EA Project No.: 16-1100

DATE OF ISSUANCE: February 14, 2017

Notice: This addendum is issued to all prospective bidders as an amendment to the Drawings and Project Manual for the Canopy Row. Bidders shall acknowledge this addendum on the Bid Form. All information contained herein shall be fully incorporated into the Contract Documents as though originally included therein.

2 ENLARGED CEILING PLAN- SUITE E ADA
SCALE: 1/4" = 1'-0"

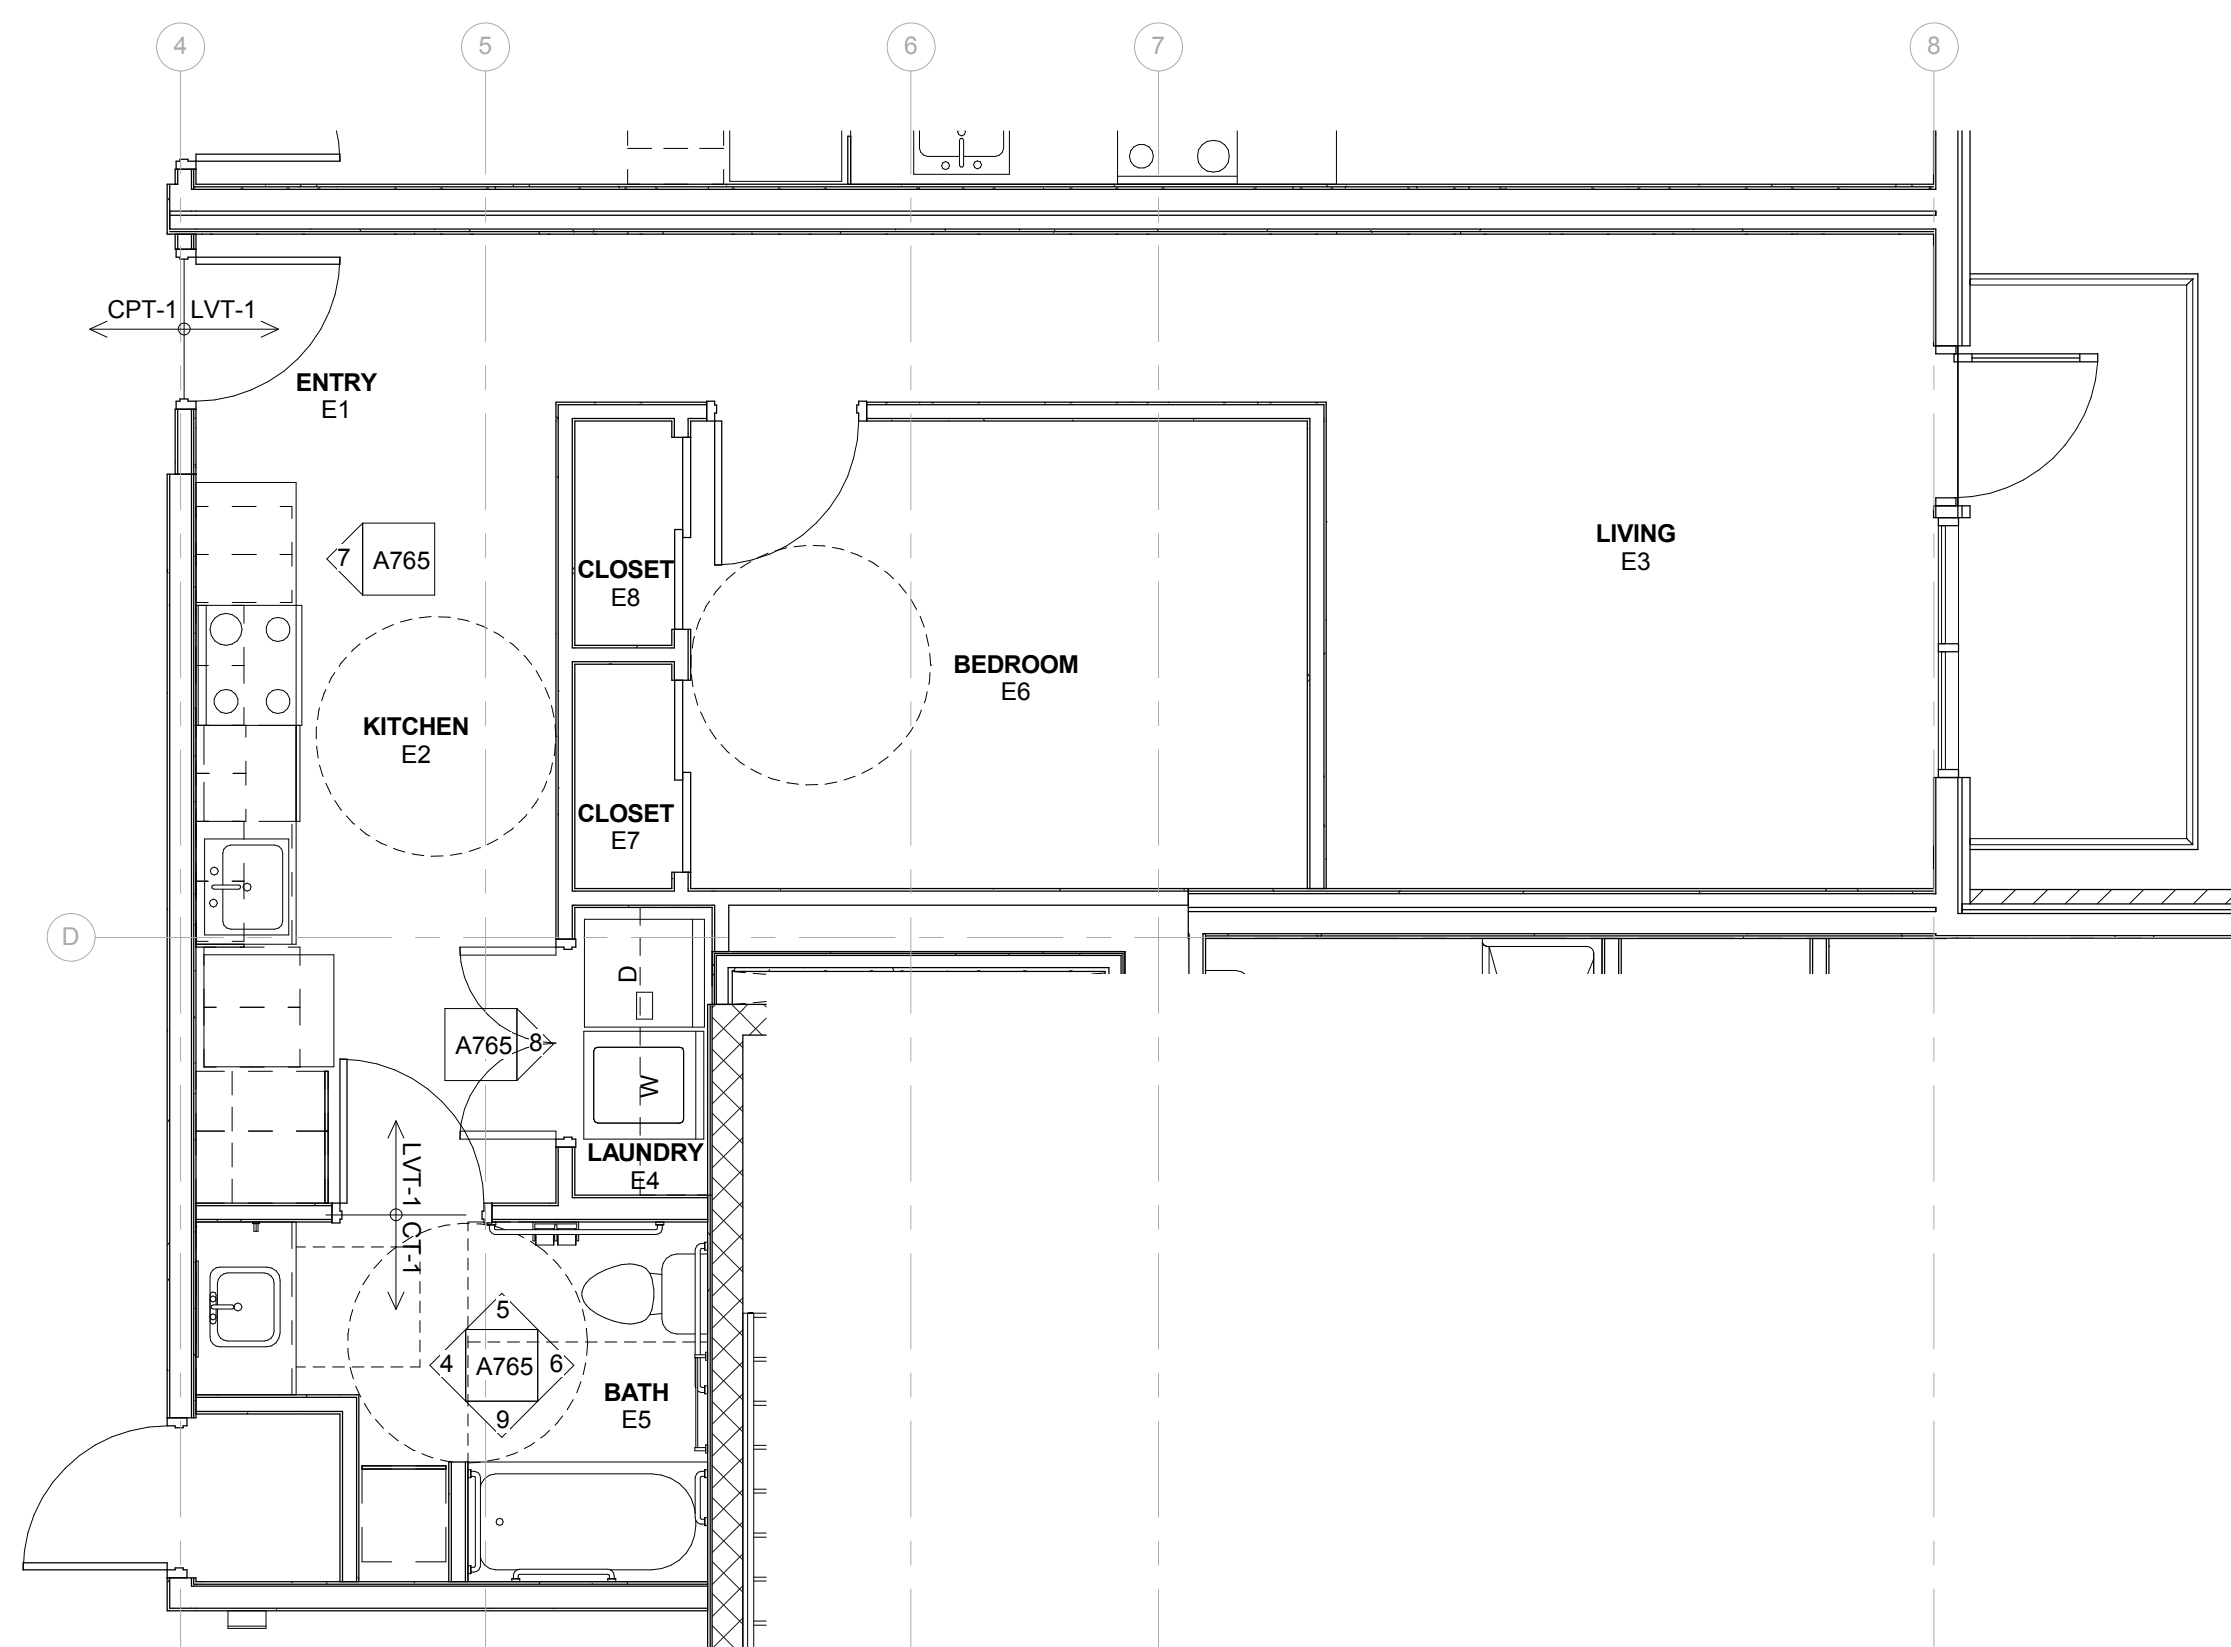
- Item AD-18. Sheet A765 – Suite E ADA
 - a. Revise details 2/A765 as indicated on attached sheet A765.
- Item AD-19. Sheet A766 – Suite F
 - a. Revise details 2/A766 as indicated on attached sheet A766.

2 ENLARGED CEILING PLAN - SUITE G
A767 SCALE: 1/4" = 1'-0"

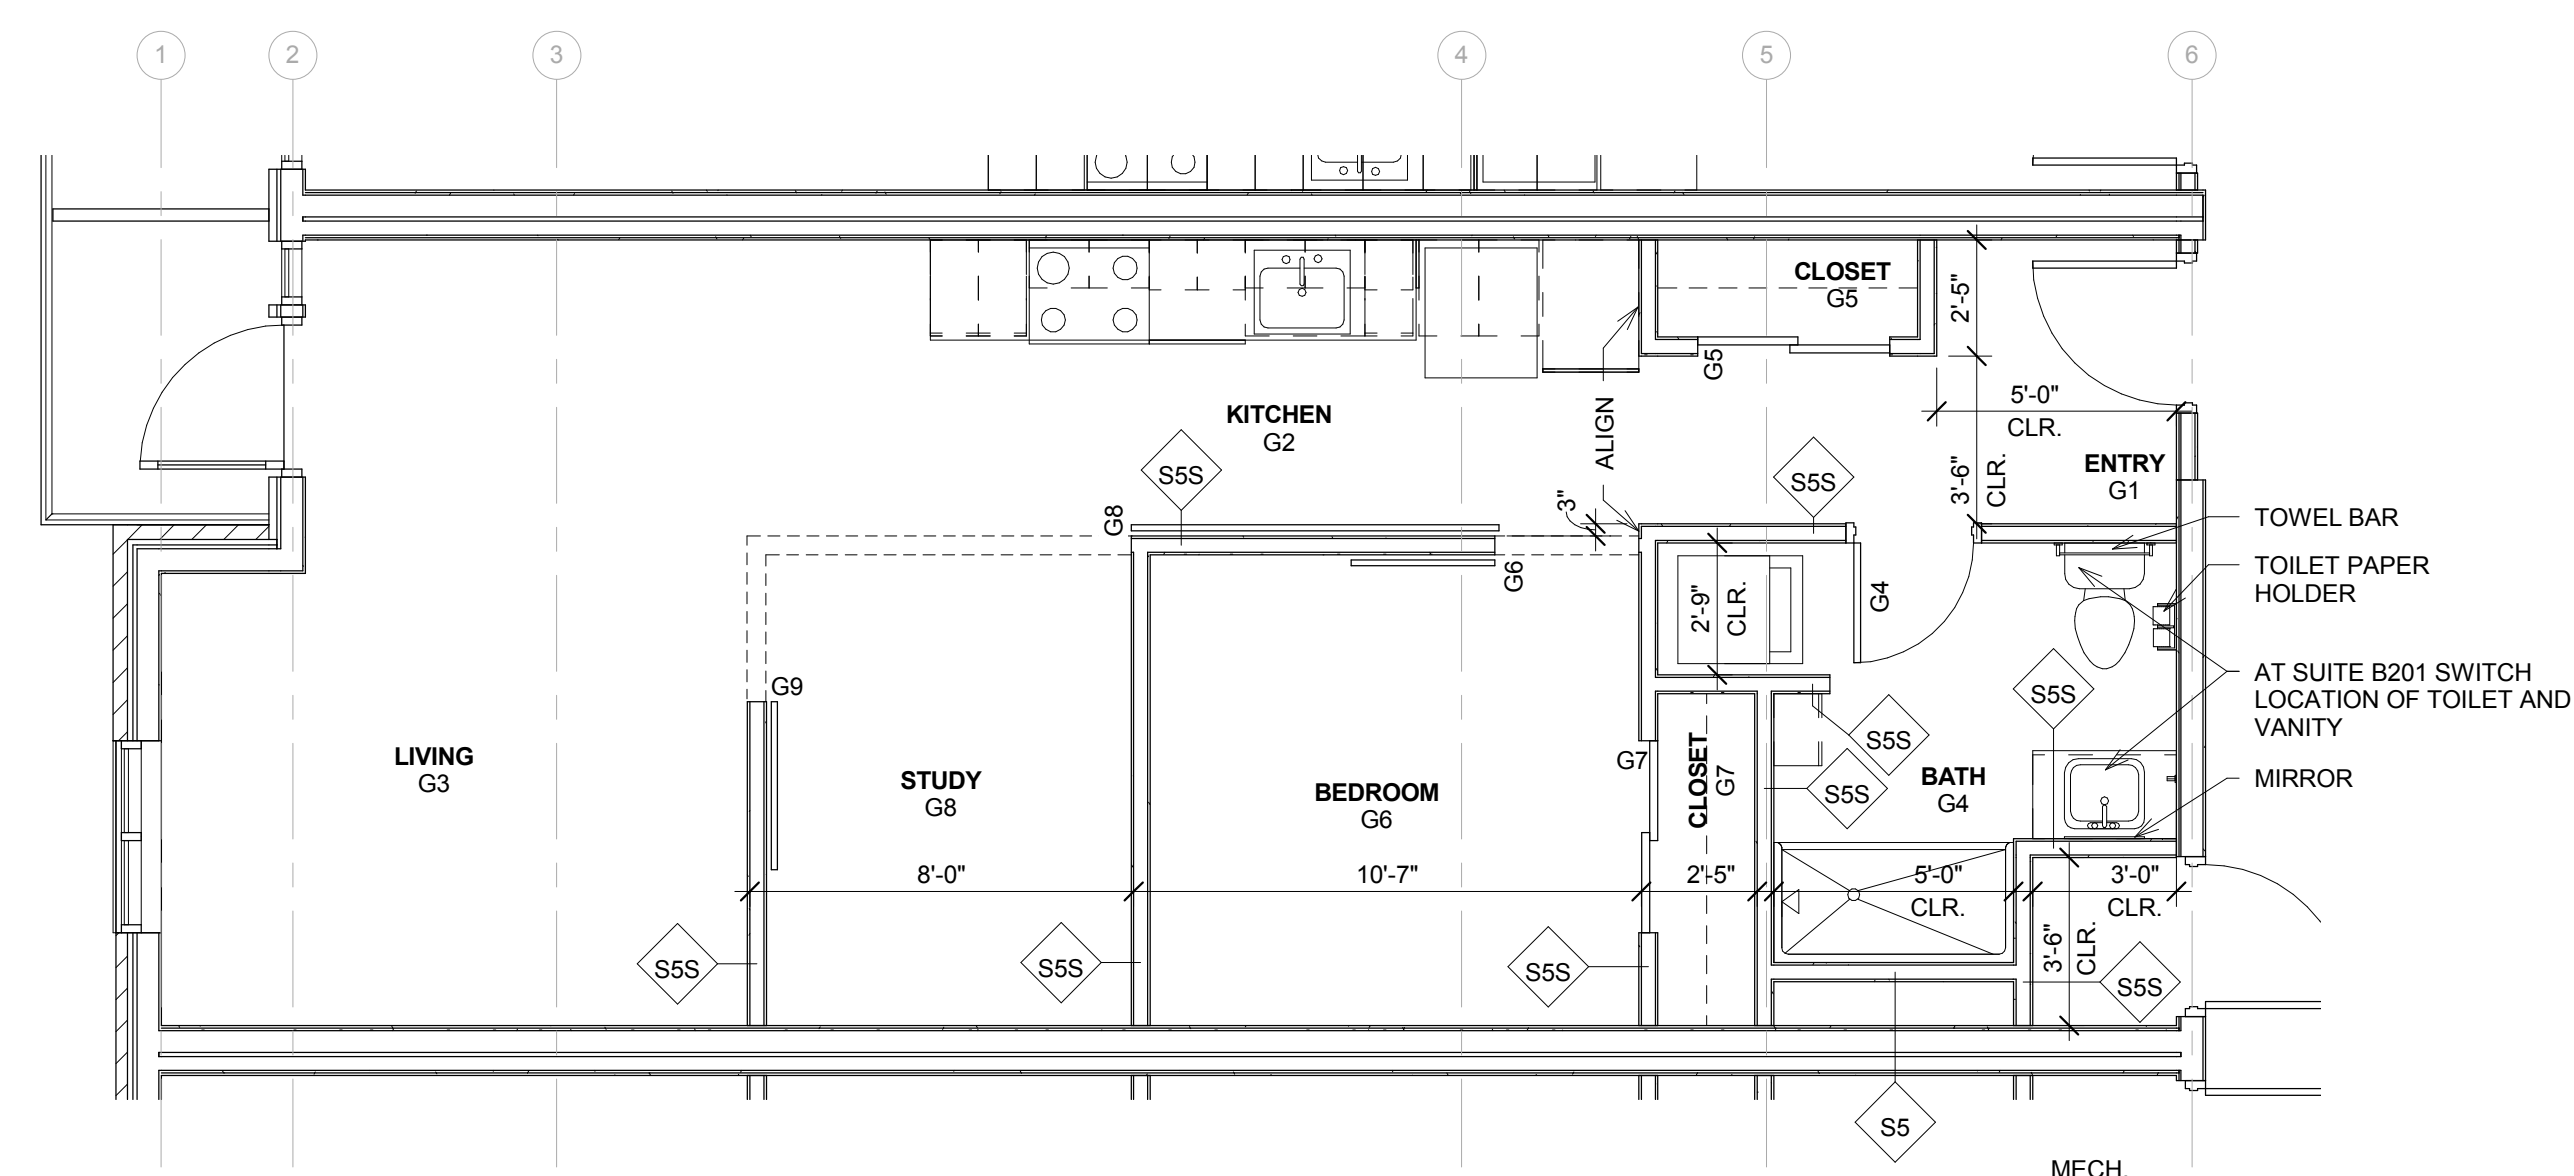
- Item AD-20. Sheet A767 – Suite G
 - a. Revise details 2/A767 as indicated on attached sheet A767.
- Item AD-21. Sheet A768 – Suite H
 - a. Revise details 2/A768 as indicated on attached sheet A768.

2 ENLARGED CEILING PLAN- SUITE J
A769 SCALE: 1/4" = 1'-0"

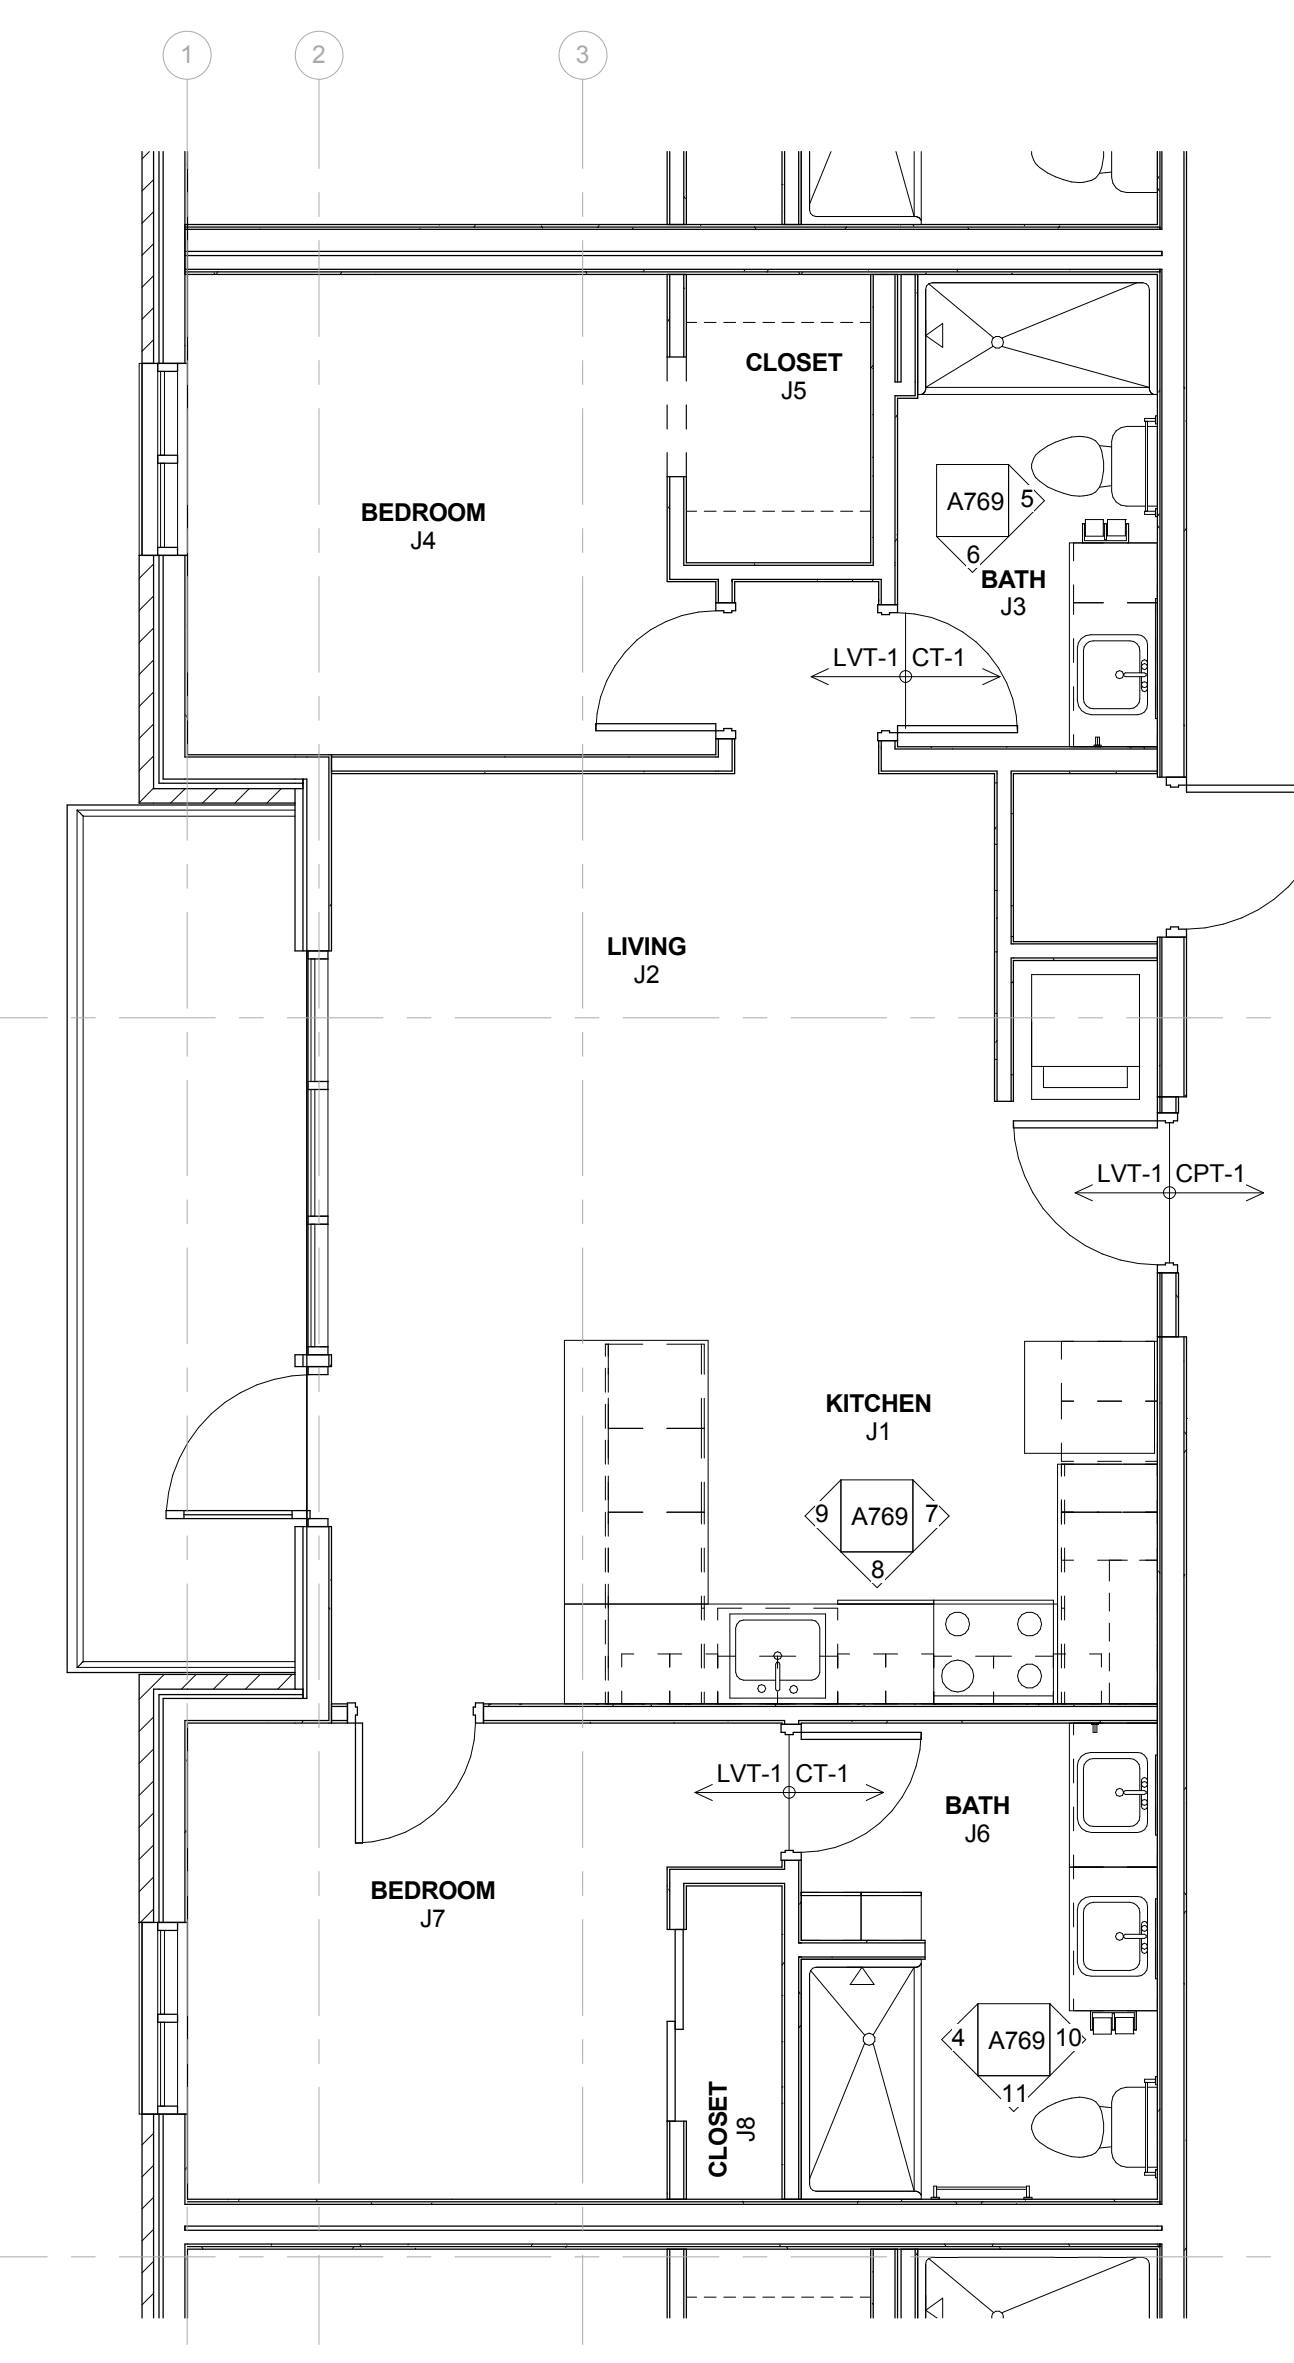
- Item AD-22. Sheet A769 – Suite J
 - a. Revise details 2/A769 as indicated on attached sheet A769.
- Item AD-23. Sheet A770 – Suite K
 - a. Revise details 2/A770 as indicated on attached sheet A770.
